# Bid Addendum 01

Project: UNC Charlotte Science Building:  
Early Package 1  
Existing Building Heating Conversions

Date: November 20, 2017

Prepared by: Mike Romot, AIA, LEED BD+C

1 MECHANICAL AND ELECTRICAL SITE PLAN  
1" = 50'-0"

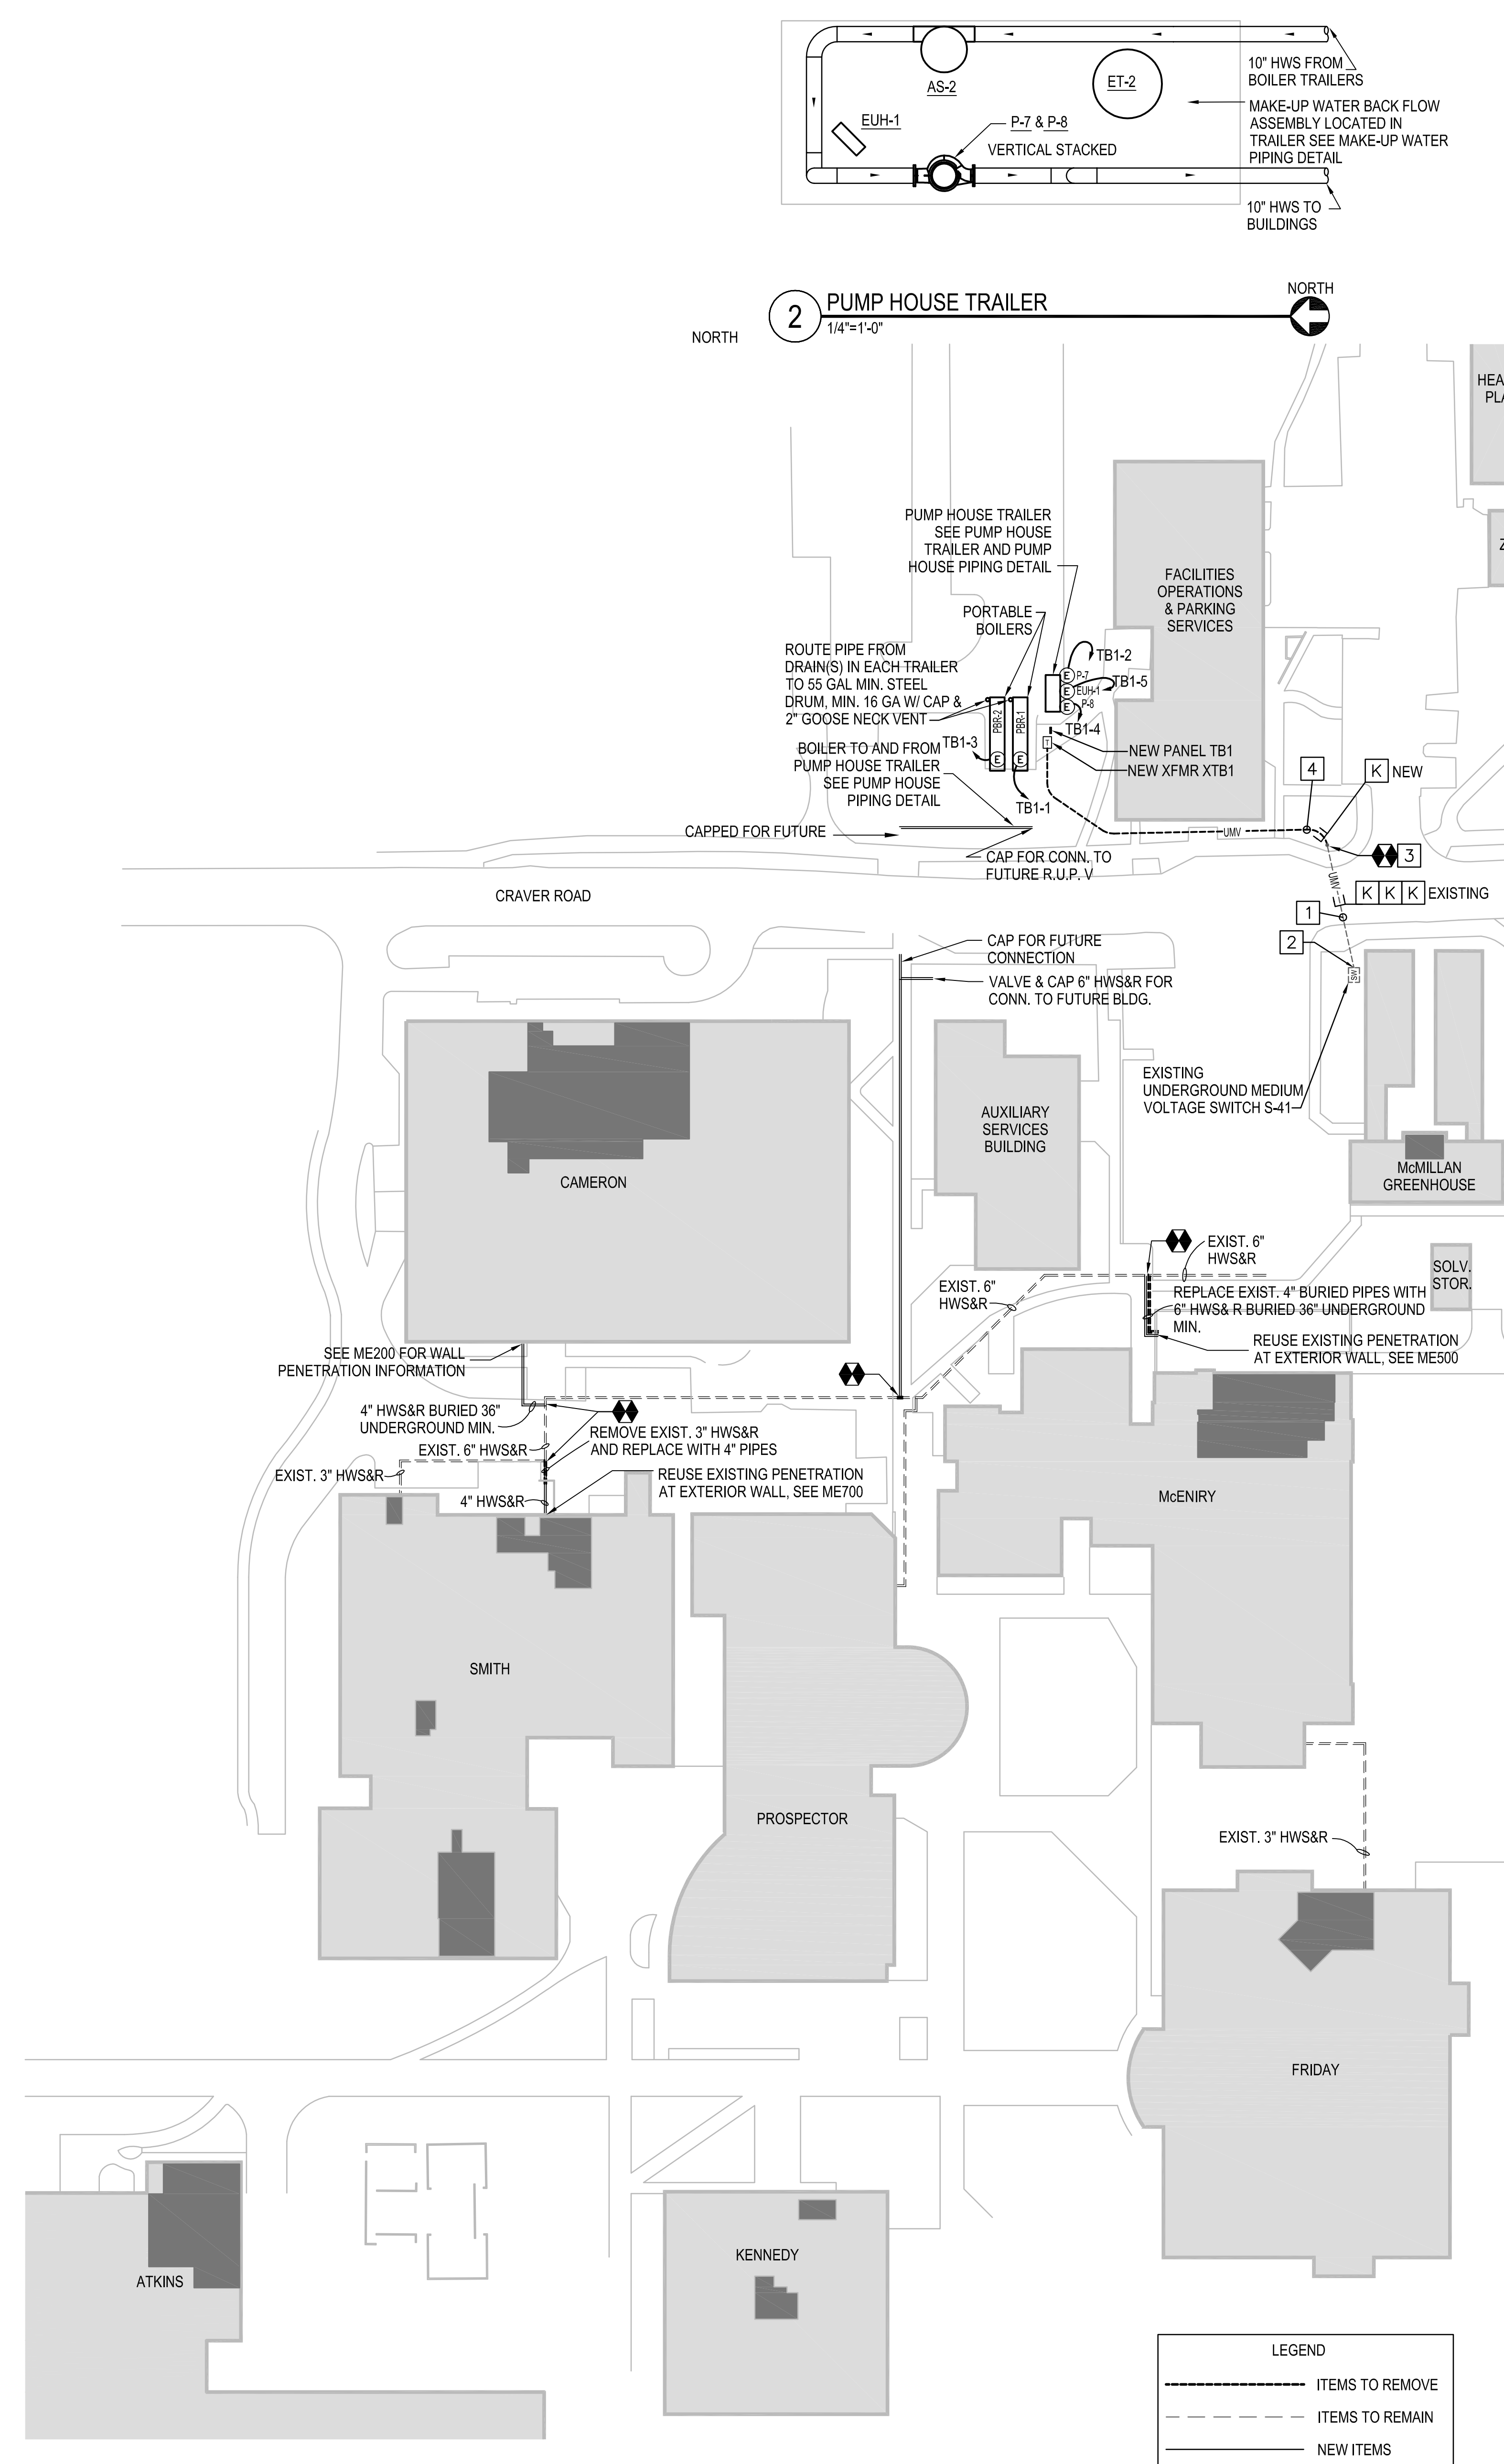
4. **HHWS/R Piping** (Detail. 1/MES01):

- a. **Main Walkway:** Detail shows connecting new 10" HHWS/R piping, at 36" grade, to existing 6" HHWS/R that shows no grade.
- b. **McEniry Connection:** Detail shows connecting new 6" HHWS/R piping, at a 36" grade, to existing 6" HHWS/R that shows no grade.
- c. **Cameron Connection:** Detail shows connecting new 4" HHWS/R piping, at a 36" grade, to existing 6" HHWS/R that shows no grade. Please provide a detail of what type of connections required.
- d. **Over Pipe Connection/ Under Pipe Connection:**
  - i. Over Pipe Connection will require a vent.
  - ii. Under pipe connection will require a drain.

Response: The pipe connections will need to be field coordinated after the exact depth of the existing piping and any other existing utilities within close vicinity are identified. The preference is to use a over-pipe connection with an air vent in lieu of a under-pipe connection with a drain.

3 PUMP HOUSE TRAILER PIPING DETAIL  
NO SCALE

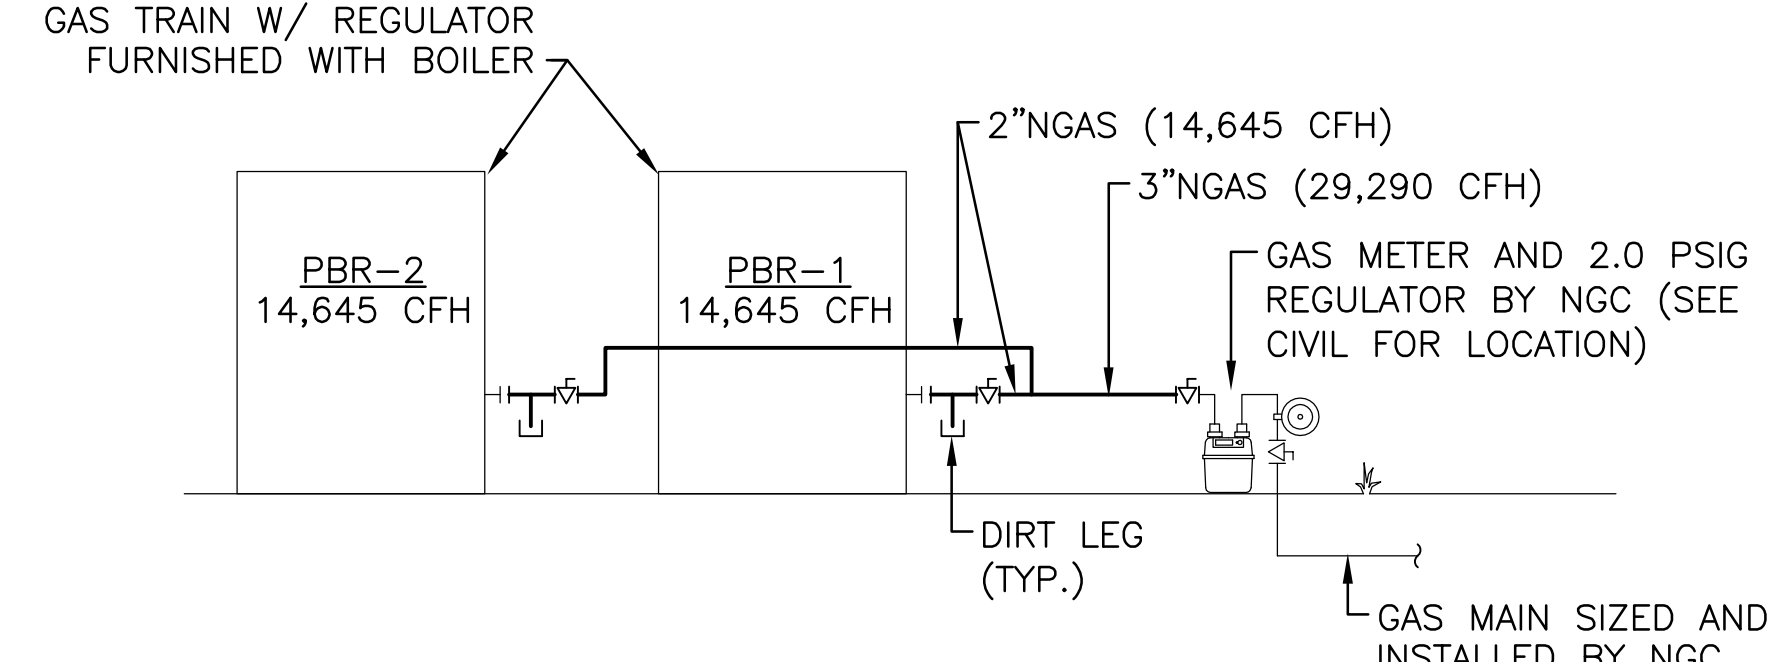
2. **Heat Trace at Temporary Trailers** (Detail 3/MES01): Will heat tracing be needed for hot water piping above grade at temporary trailers locations? If so, please provide watts for heat tape.

Response: Heat tracing is not required for the heating water pipe.
